Subject: Bishop Tube Public Comment

**Comments on the Bishop Tube Site 8/17/2021
Analysis of Alternatives and Proposed Response**

The following are comments on the 8/17/2021 *Analysis of Alternatives and Proposed Response* (the “AOA”) for the Bishop Tube Property, East Whiteland Township, Chester County (the “Site”¹) from the Hazardous Sites Cleanup Program of the Commonwealth of Pennsylvania, Department of Environmental Protection (the “Department”).

I write to provide comments on the *Remedial Investigation Report (RIR)* and *Feasibility Study Report (FSR)* regarding the Former Bishop Tube Property, East Whiteland Township, Chester County, Pennsylvania, authored by Roux Associates, Inc. (2019a and 2019b). As you will read, I find that the analyses presented in the RIR are deficient in several respects; and I offer suggestions for improving upon these analyses. Because the FSR is based on the RIR, it too is unreliable.

Figure 1 Comparison of sampling in MW-23 and MW-06

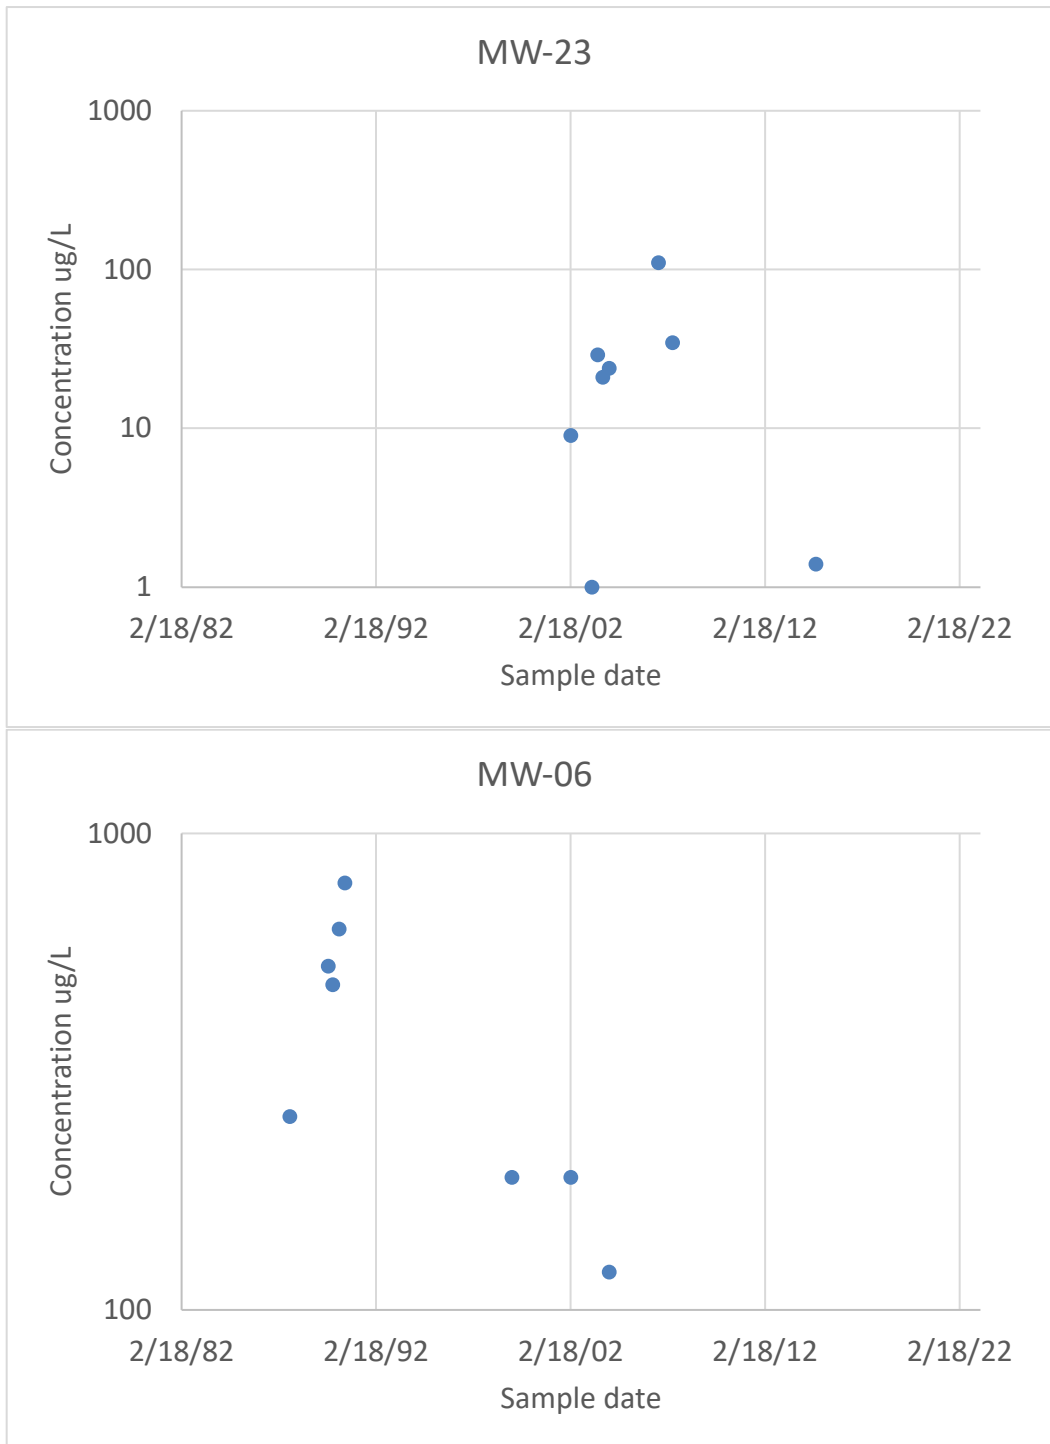
- c. It is difficult to conceive of any consistent specification that would include MW-23 but exclude MW-06, as is done in the RIR (see Figure 1).
 - d. The methodology adopted in the RIR was to average the “half-lives” calculated by linear regression over all available measurements in Table B-1 for the wells in Table 2 of Appendix S. This methodology is incorrect, however, for at least two reasons. First, if such averaging over wells were appropriate, then the correct methodology requires averaging over all “decay rates” (both positive and negative), not averaging over “half-lives” (essentially the inverse of “decay rates”). Second, performing such averaging assumes that the average has some physical meaning — that the “decay rate” measurements in individual wells are all (imperfect) measures of the same quantity applicable to the whole site — but in this case, examination of the distribution of “decay rates” shows that the measurements are in fact not of the same quantity. Figure 2 shows a normal probability plot of the “decay rate” (λ) for all 51 monitoring wells satisfying the first criterion (≥ 4 points, ≥ 4 years). This distribution is indistinguishable from normal,⁵ and clearly the measurements are not all consistent with a single mean value. A formal likelihood ratio test confirms this — maximum likelihood estimates of mean and standard deviation of a normal distribution are 0.00029 per day and 0.00024 per day respectively, taking account of all the individual uncertainties, and the standard deviation estimate is non-zero ($p = 1e-97$).

Figure 3 Measured concentrations, the RIR “fit” to those concentrations, and a fit to those after 1995, and the modeled concentration in MW-15, with a line showing the assumed decay rate.

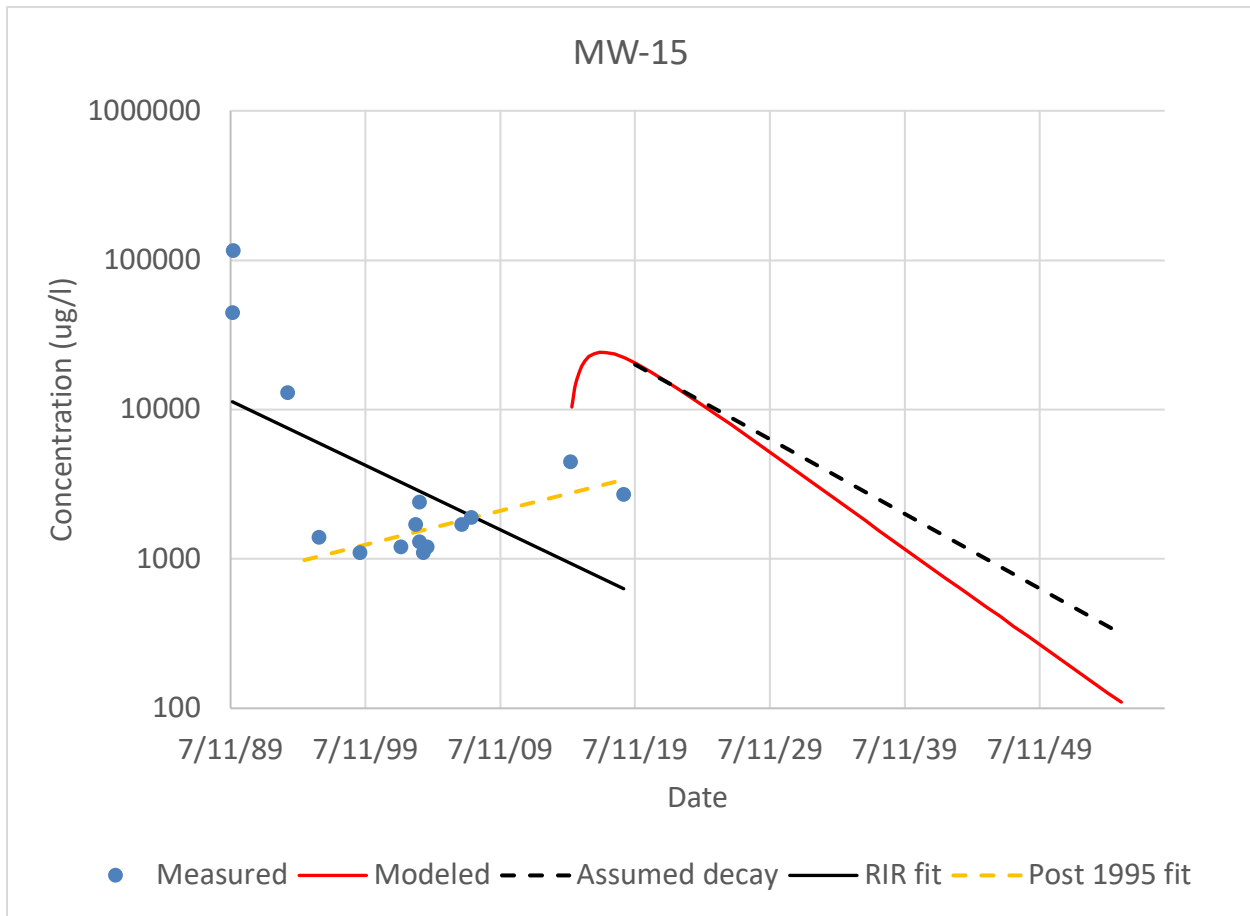
Figure 3 (MW-15) also illustrates the disconnect between measured concentrations and the RIR modeling, for this well at least. The initial peak in the modeling is due to a higher concentration part of the plume passing by MW-15, and the faster drop-off in concentration at large times (compared with the decay rate, illustrated by the dashed black line) is due to the reducing concentration behind that higher concentration part of the plume (MW-15 is situated so that, in the modeling, a kink in the assumed 10,000 µg/L contour will sweep across it as the whole plume migrates down-gradient; see Figure 46 of the RIR).

Figure 8 The absolute worst-case estimate of plume centerline concentration using the RIR model.

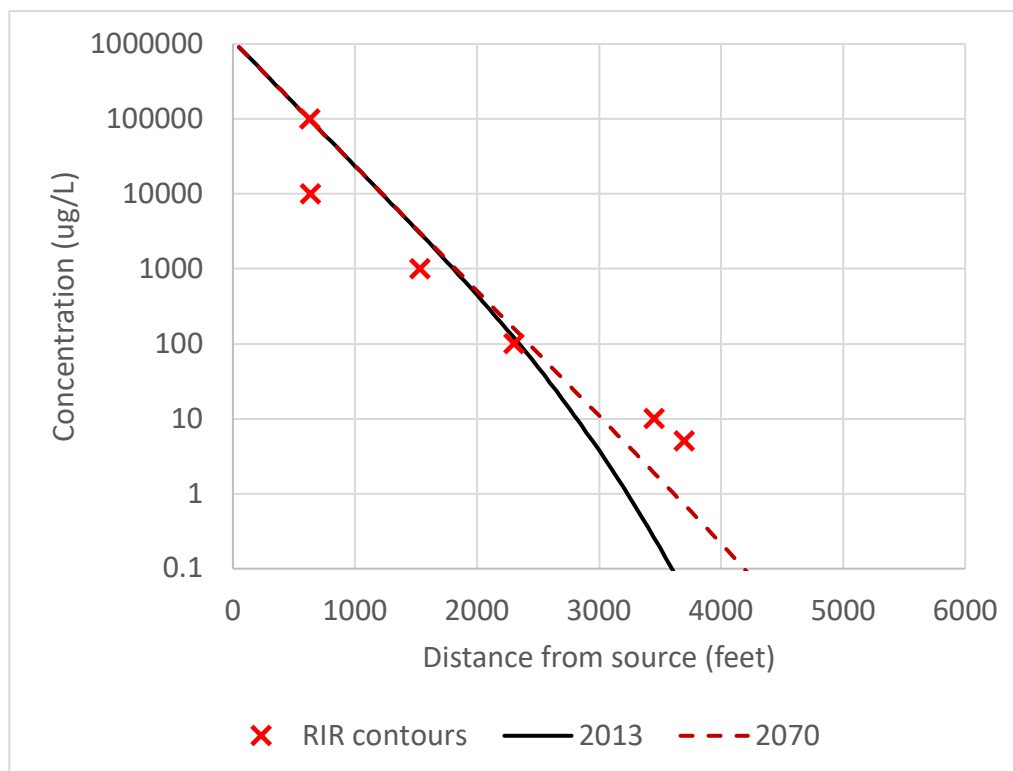
Clearly, with the parameter values used in the RIR, this worst-case plume would be in steady state out to 2,000 feet in 2013, and out to beyond 4,000 ft by 2070, and the 5 $\mu\text{g/L}$ contour would never extend beyond about 3,200 feet.

Figure 9 Showing that a constant source can match the RIR results with just a change in hydraulic conductivity.

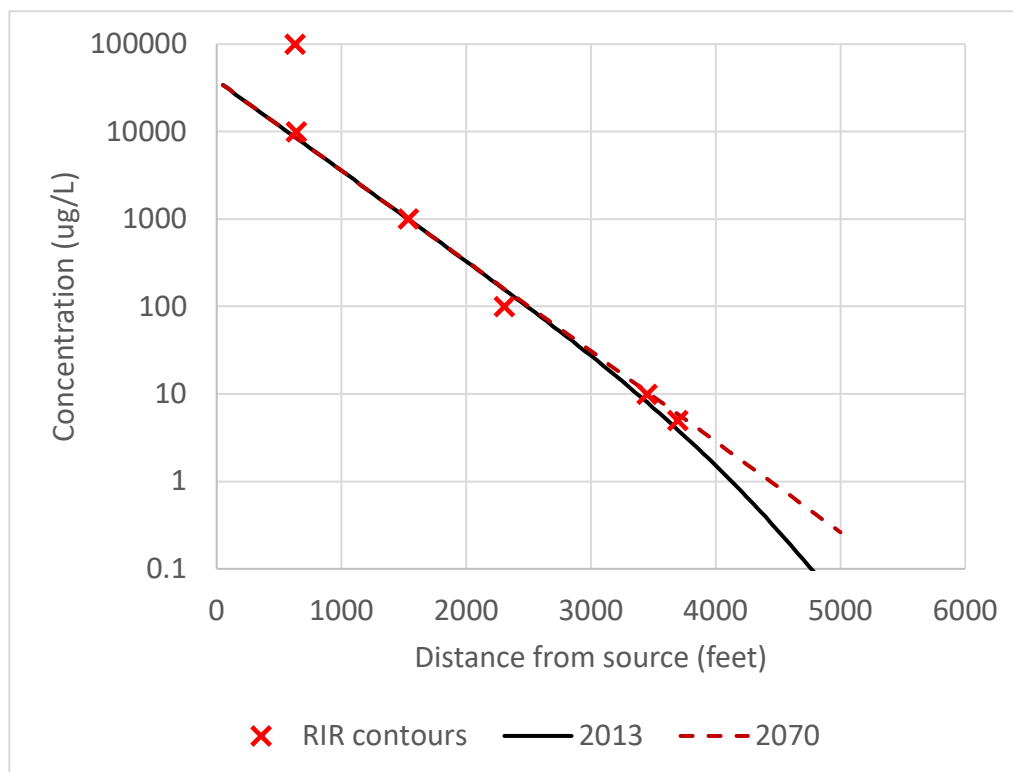
example, simply increasing the estimated hydraulic conductivity to 2.129 ft/day and reducing the assumed (constant forever after 1951) source term gives Figure 9, which shows a plume in practical equilibrium to about 2,500 ft by 2013, and beyond 5,000 feet in 2070.

Figure 10 An example showing that the RIR might have substantially underestimated potential plume extent; and the effect of an immediate source term cleanup.

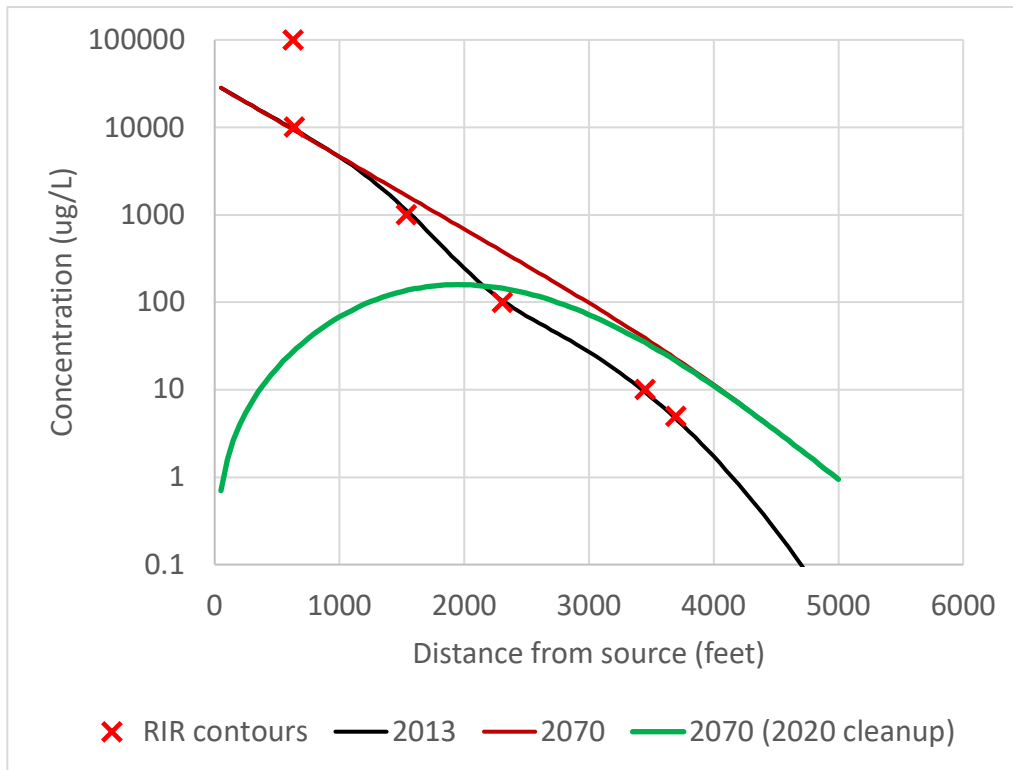
Also shown on Figure 10 is the effect of stopping the entire source completely in 2020, to illustrate the importance of immediate action. The hypothetical source term was selected so that, in 1991, 70% of the source at that time was removed in an effort to illustrate the potential effect of stopping TCE releases at the site at that time. Any DNAPL TCE in the bedrock at that time would sink to deeper levels, with some presumably remaining trapped in blind pockets throughout the rock column. Gradual dissolution of both sources would probably provide a substantially reduced source strength compared with DNAPL TCE still flowing through the rock column. However, TCE present as DNAPL in or adsorbed to soil above the rock column would not be so affected by such a change — that would still be available for leaching into groundwater. Unfortunately, the RIR makes no attempt to evaluate the relative sizes of these sources, but merely assumes that both vanish entirely — the TCE in the rock column by implicit omission, and the TCE in the soil by simply assuming it away. Figure 10 arbitrarily assumes that the rock column is a negligible source after 1991, and that leaching from the soil could amount to 30% of the total at that time (and could continue forever). Removing the soil in 2020 would then correspond to the green curve, showing a substantial reduction in concentrations over the first 3,000 ft of plume by 2070.¹¹

Figure 12 Concentration versus date curves at various distances for the clean-up scenario in Figure 10

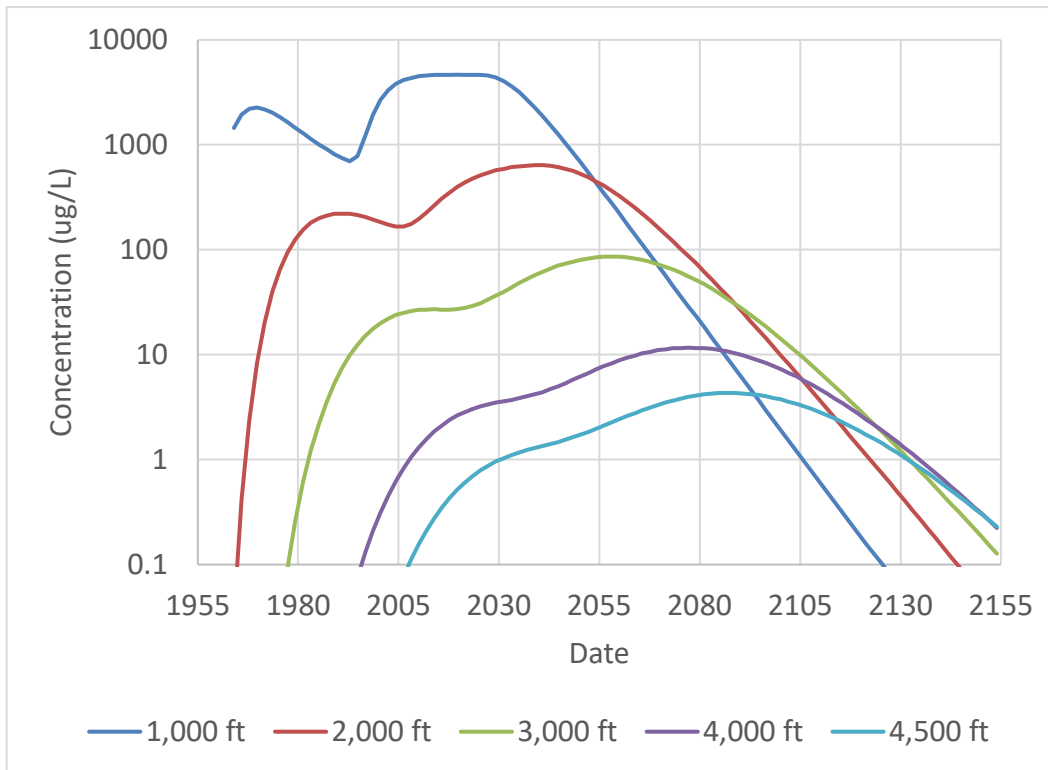
The concentration versus date curves corresponding to the cleanup scenario of Figure 10 are shown in Figure 12. Further noteworthy (and generic) features (compared with Figure 11) are:

- After a time delay corresponding to the propagation time from the source, the concentrations start to decline almost exponentially with time.
- Despite the appearance on Figure 12 that the declining curves could be parallel and straight, the exponential declines are different at different times and distances, and none of them correspond to the TCE degradation half-life (they are more rapid).

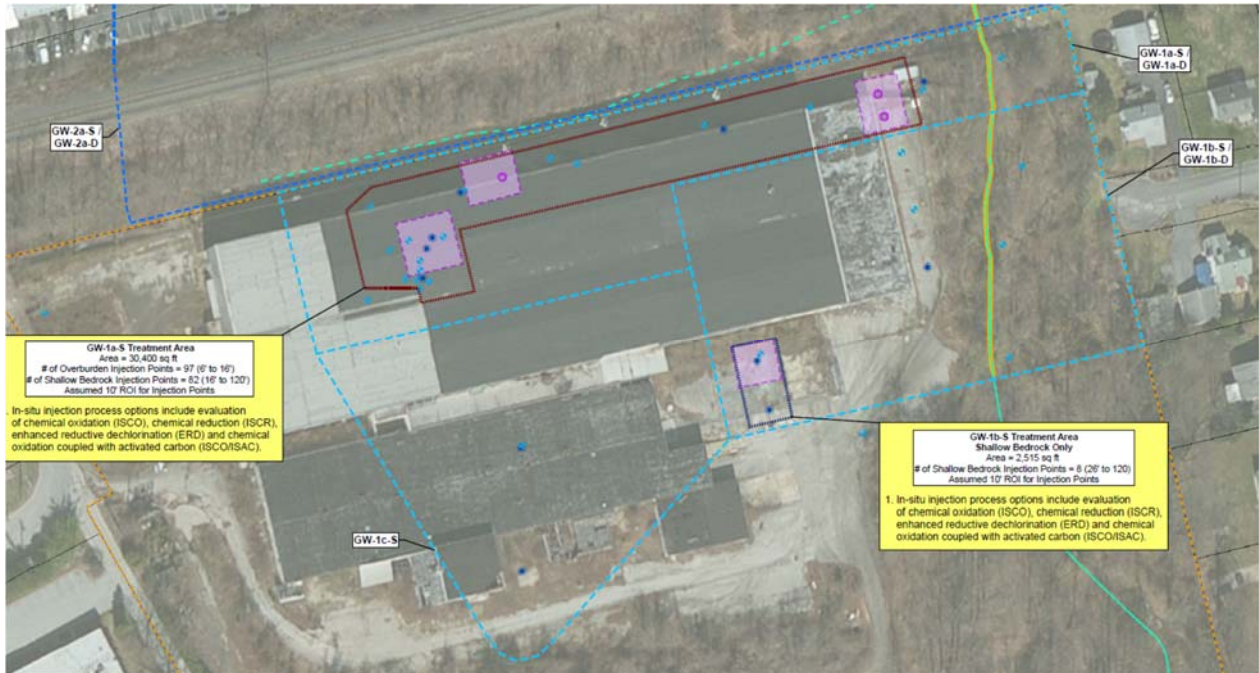
The injected chemicals are more viscous than water. Therefore, they will remain close to the injection point rather than moving quickly with groundwater flow. Especially in the shallow

bedrock, the injection solutions would flow through the more pervious fractures. Because the solutions would probably be heavier than water, they would sink deeper into the fractures rather than move as part of the groundwater flow. There would be a chance for the amendments to flow into lower permeability fractures, through diffusion and dispersion, just as groundwater otherwise moves into those fractures. Because of the high viscosity and being heavier than water, the treatments would be effective only near the point of injection. The FS does not analyze the radius over which it could be effective as it must do before DEP can select a density of injection locations. The FS also does not consider injecting chemicals directly into deep bedrock, even into obvious hot spots under or just northeast of the site. This is a failure that would allow a substantial amount of TCE go untreated and remain as a source in deep bedrock.

Figure 7: Snapshot from FS Figure 20a showing location of extraction and reinjection zones for offsite areas for alternative 7

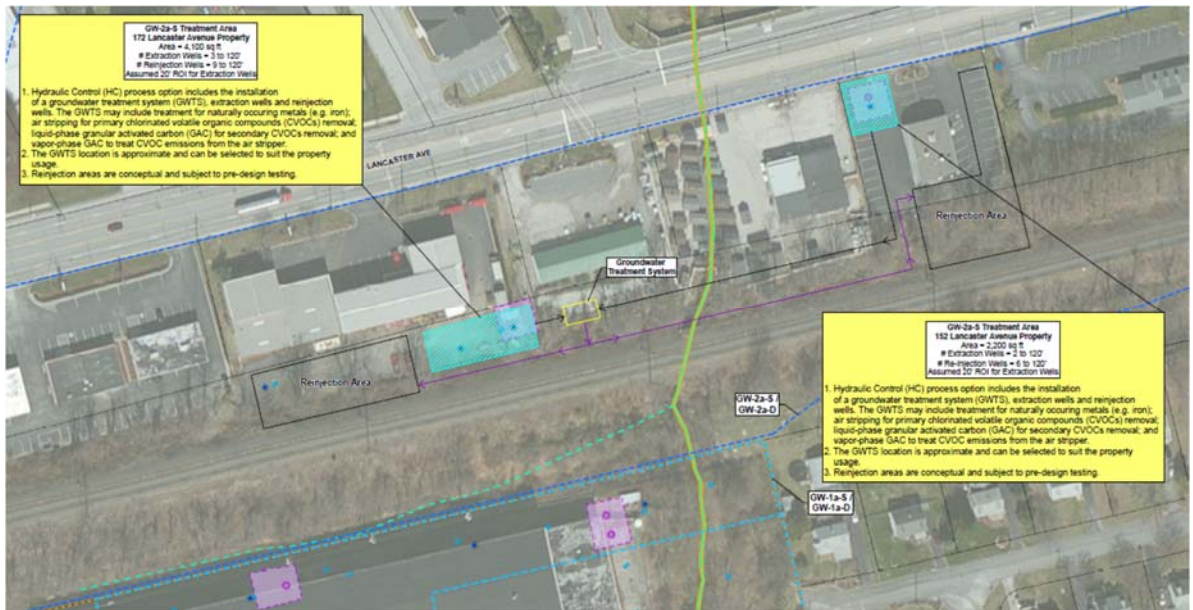
Offsite HC would focus on pumping near the DNAPL source areas (Figure 7). The northeastern most extraction area is near the very high TCE MW-79 and MW-51. The westerly extraction site is at the high concentration site MW-28. However, extraction would be from shallow bedrock and the high TCE concentrations are in the deep bedrock. The alternative would not pump from near the source but would simply remove mostly clean water above the source. The FS does not consider the value of capturing groundwater near the source in deep bedrock.

Figure 8: Snapshot of FS Figure 22 showing the conceptual design of best management practices to protect LVC.

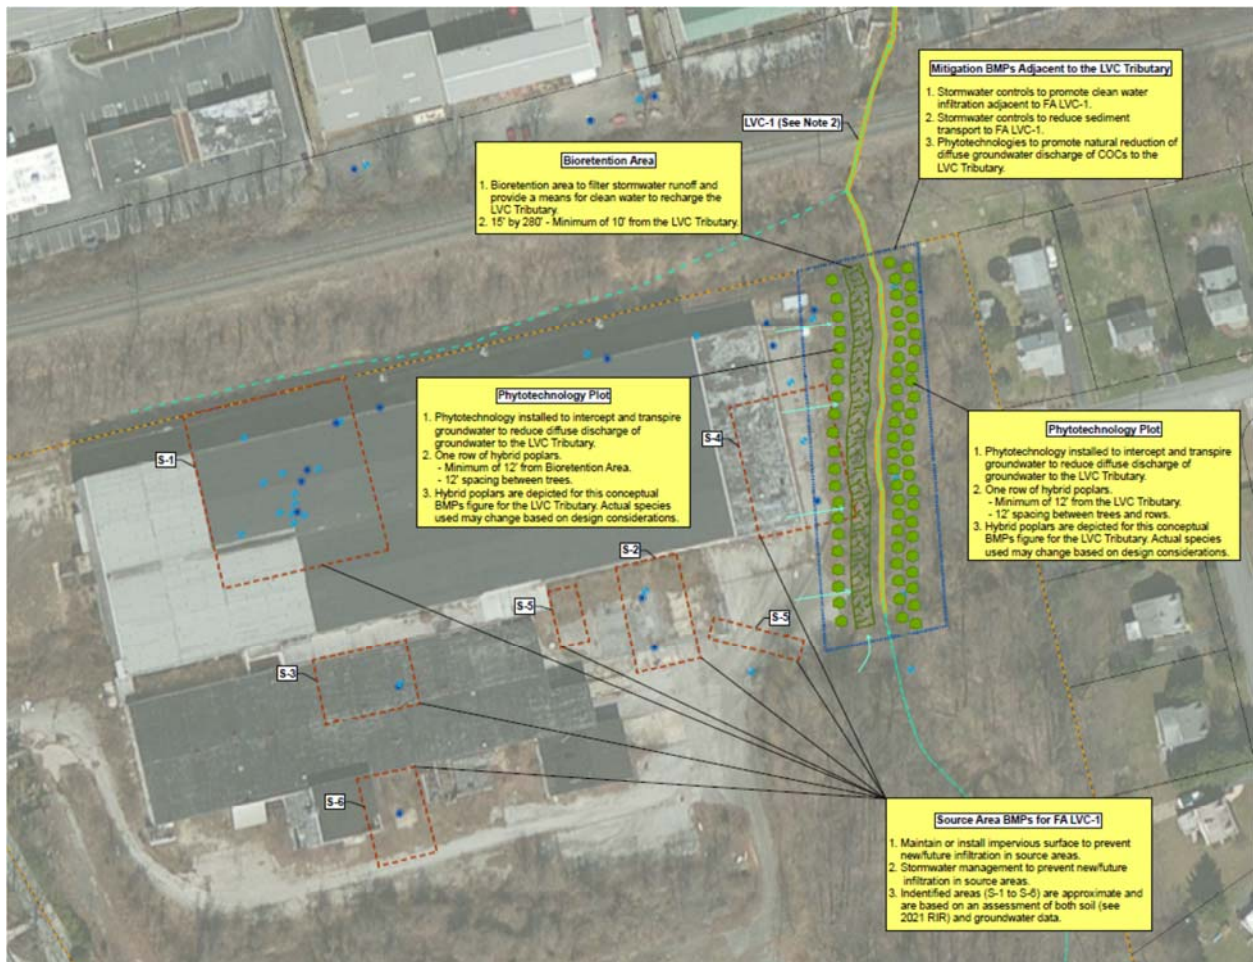
The first BMP proposed is that the six primary source regions, three for CVOCs and three for metals (Figure 8), be capped with an impervious layer. There is no consideration of how this would work with future development of the site. There is no consideration of the need for an impervious cap if the source within the soil is completely removed. There is also no consideration of a water balance barrier which would use most of the infiltration for plant growth and limit infiltration of CVOCs substantially.
